RECALL BULLETIN 06V-462

DATE: JANUARY 22, 2007
MODEL YEAR: 2006 thru Early Production 2007
CHASSIS MODEL: UD3300
BULLETIN NUMBER: 06V-462

VOLUNTARY SAFETY RECALL CAMPAIGN NUMBER 06V-462 : ALLISON TRANSMISSION SHIFT LEVER INSPECTION/REPLACEMENT

Figure 1 (Incorrect Lever) - With "P" Park position
Replacement of the shifter assembly is required.
Proceed with Step 2 of this bulletin.

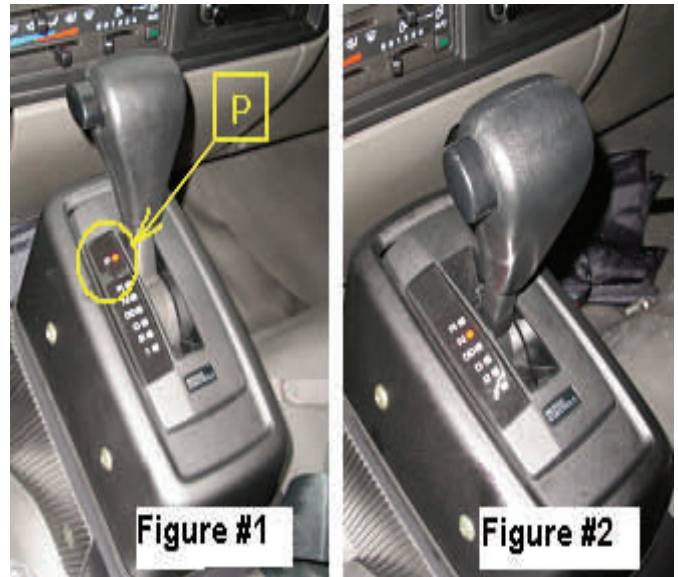
Inspect the Transmission Shift Lever Assembly and determine if a "P" Park position is present on the shifter and proceed as follows.

Figure 2 (Correct Lever) - Without "P" Park position
No further action is required.
Proceed with Step 4 on Page 5 of this bulletin.

Inspect the transmission shift lever assembly to determine whether the assembly indicates incorrect "P" park position. If incorrect, the shift lever assembly will be replaced with the correct transmission shift lever assembly at no charge to the customer.

Figure 7

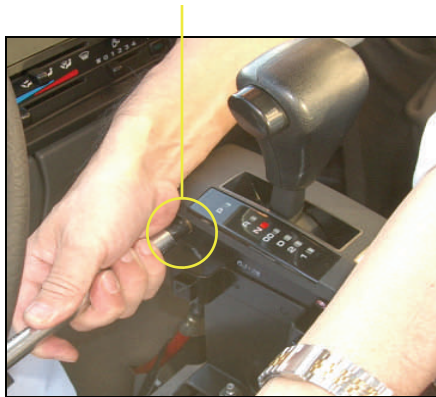
E) **Figure 7** - Remove the four bolts attaching the shifter to the shifter housing.

Figure 8

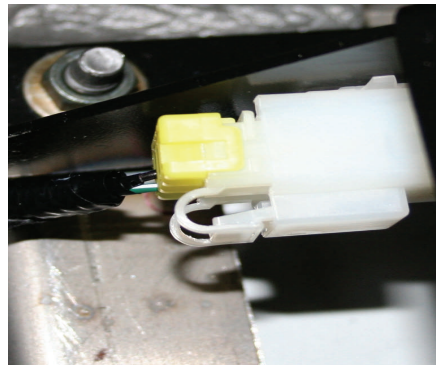
F) **Figure 8** - Unplug electrical connection at base of the shifter.

Figure 9

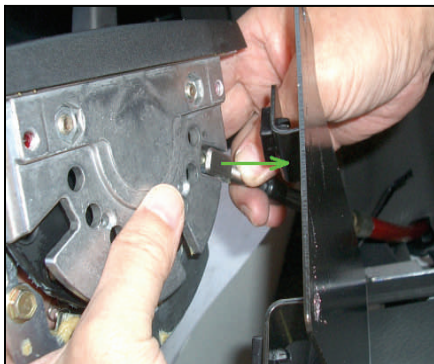
G) **Figure 9** - Set the shift lever between the "R" and "N" position. Disconnect the shift cable from the shifter assembly and remove shifter from vehicle.

H) Install new shifter in reverse order.
